Re: S/D 90-48 - (Final Plat) Cedar Meadows Addition

STAFF REPORT
(Final Plat)

CASE NUMBER: S/D 90-48 - CEDAR MEADOWS ADDITION

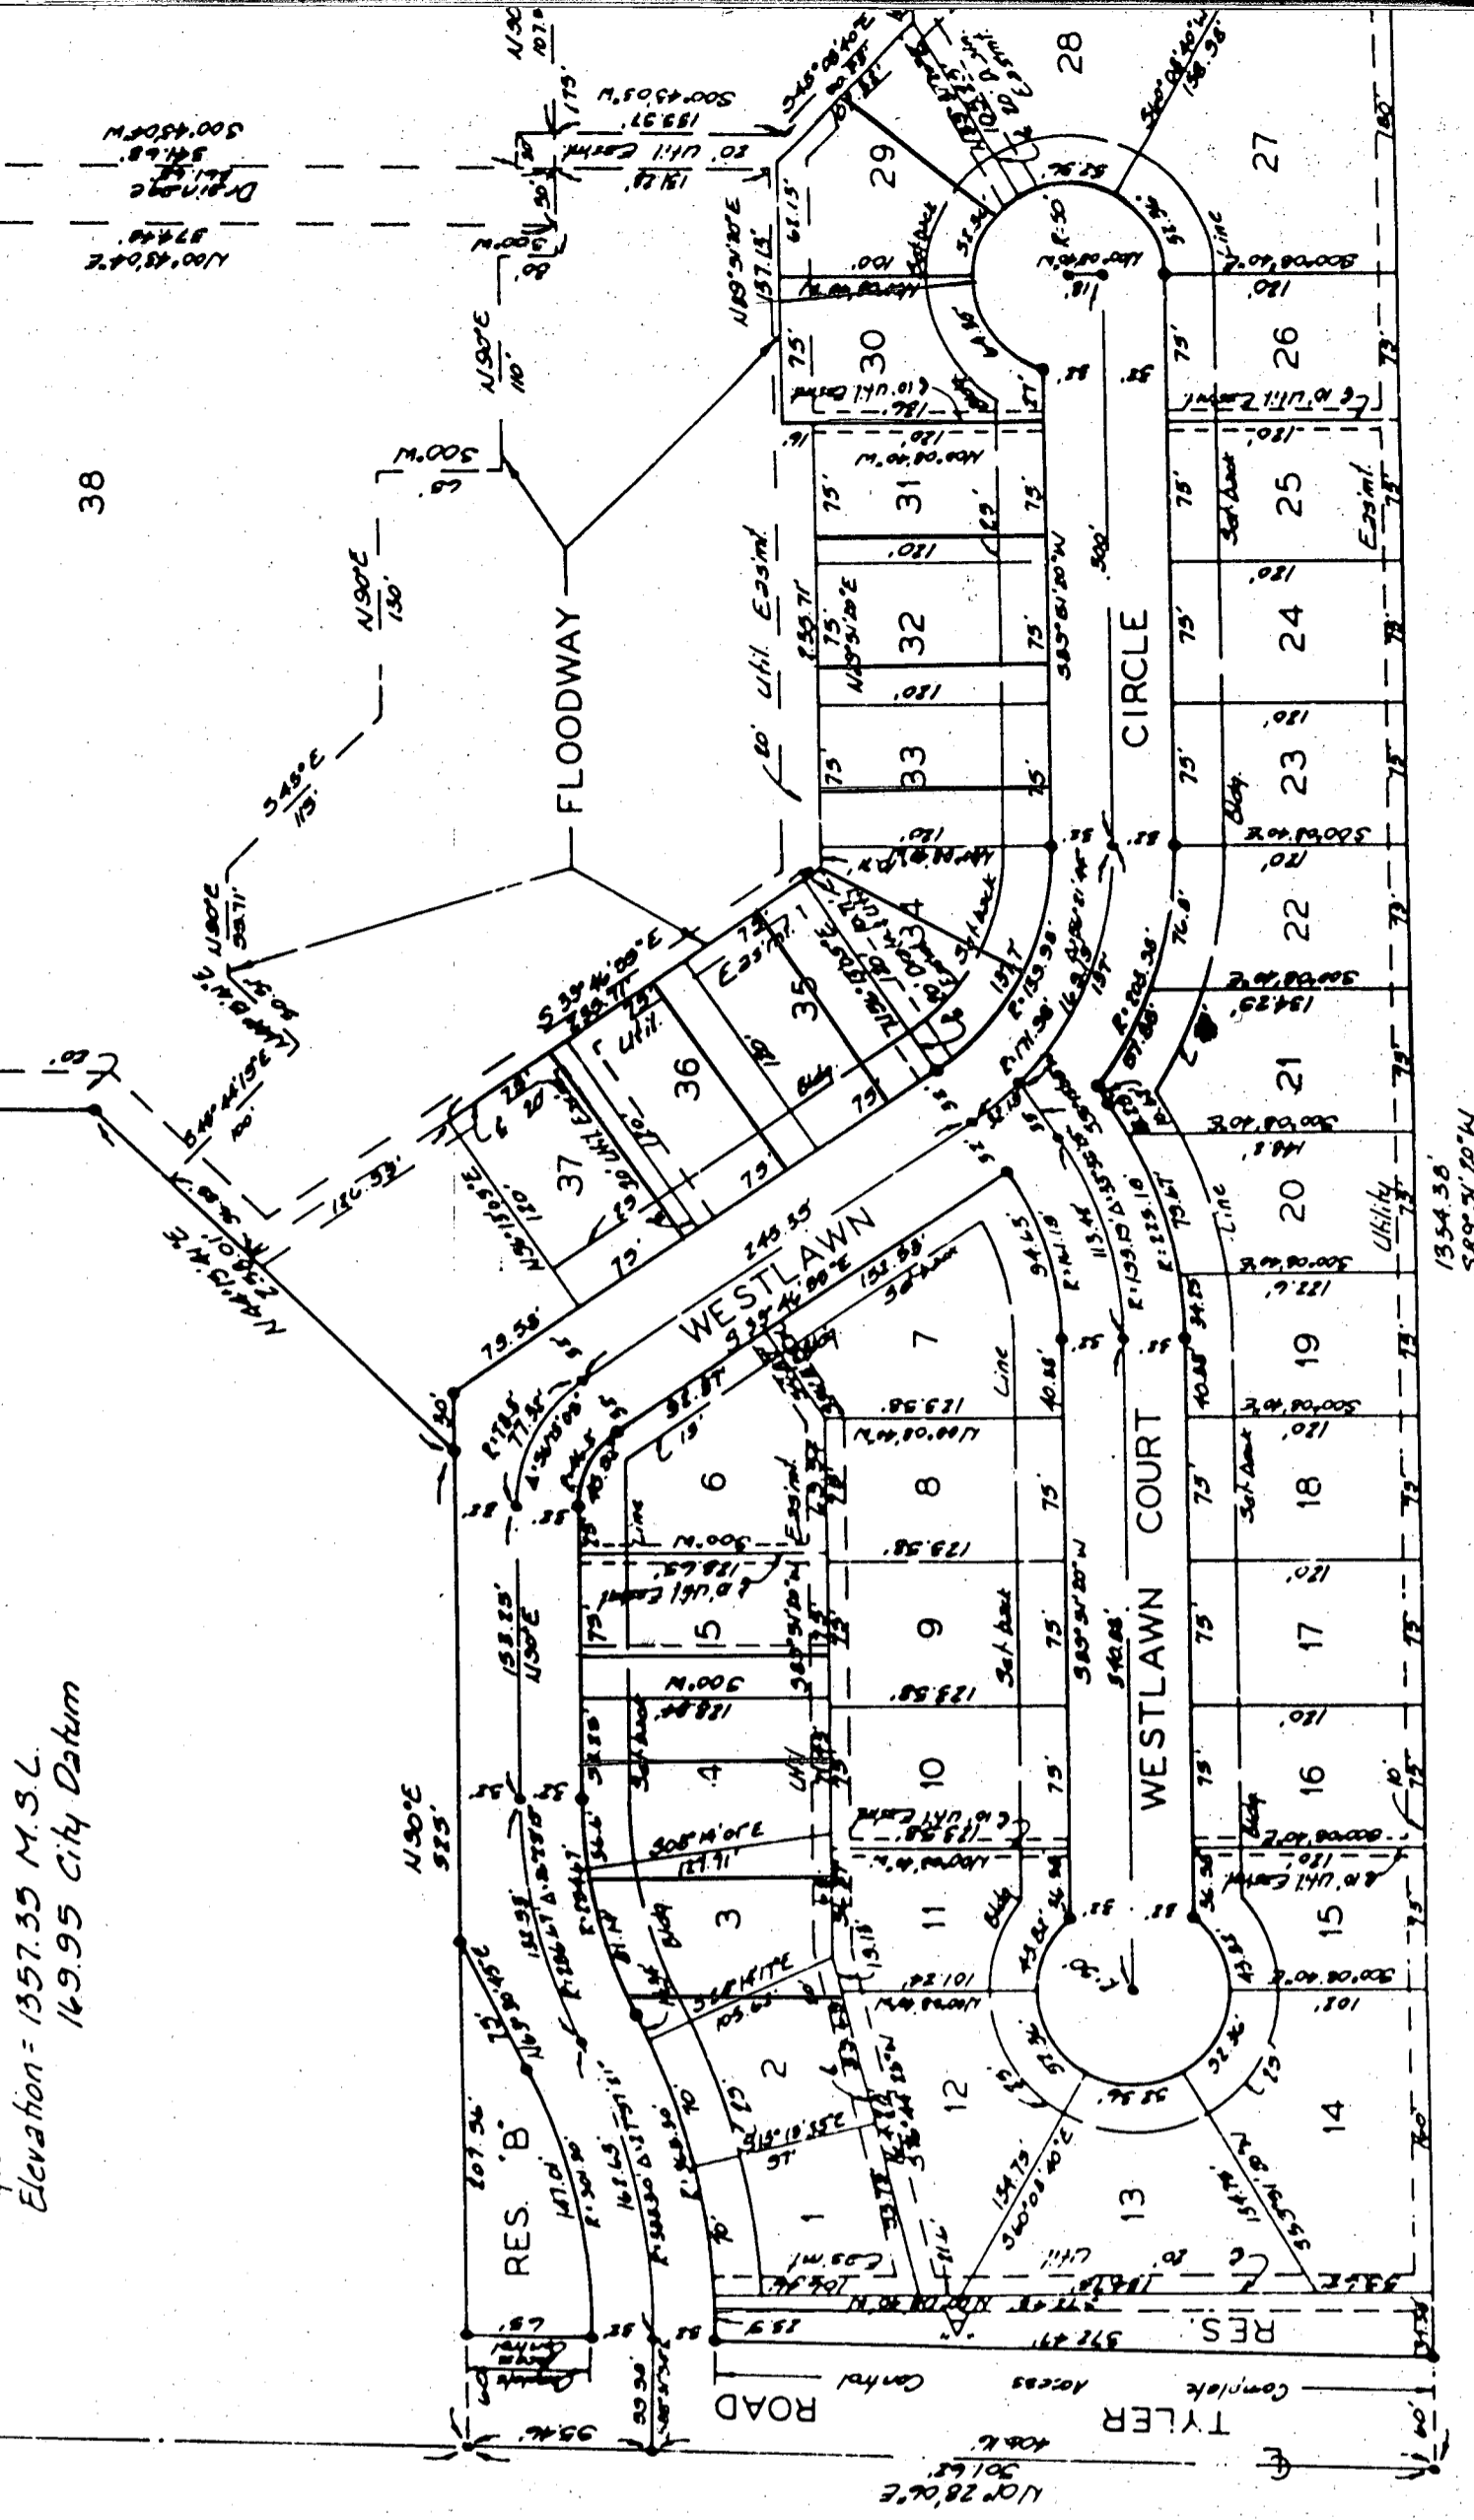
- F. On the final plat, as indicated in the CUP for 64-foot street rights-of-way, 25-foot building setbacks shall be indicated as the front yard setback for all residential lots.
- G. On the face of the plat and in the plattor's text, it shall be indicated if the minimum building pad elevations refer to the minimum floor or opening level.
- H. On the final plat tracing, the following revisions shall be made to the plattor's text:

Line 3 shall be revised to indicate "platted into Lots, Reserves and streets. . ."

The reference to the Westlawn Court Cul-De-Sac being dedicated, noted in the lower section of the text should accordingly be deleted and replaced with the standard reference of "The streets are hereby dedicated to and for the use of the public."

On line five, the word reserved has been repeated and needs to be corrected.

Reserve D shall also be indicated as intended for "the preservation of the existing row of trees."

In regard to the location of openings being allowed in the areas of access control it shall be indicated that the City Engineer is to approve the location of any such openings.

- I. As requested by KG&E, the final plat tracing shall indicate a 10-foot utility easement along Lot 37 and 38's common lot line and between Reserve B & C's and Lots 1 and 2's common lot lines.

- J. As indicated by this site's drainage plan, off-site drainage easements shall be provided for this plat. These easements shall be provided to Engineering for approval and to Planning for recording with the plat's approval.
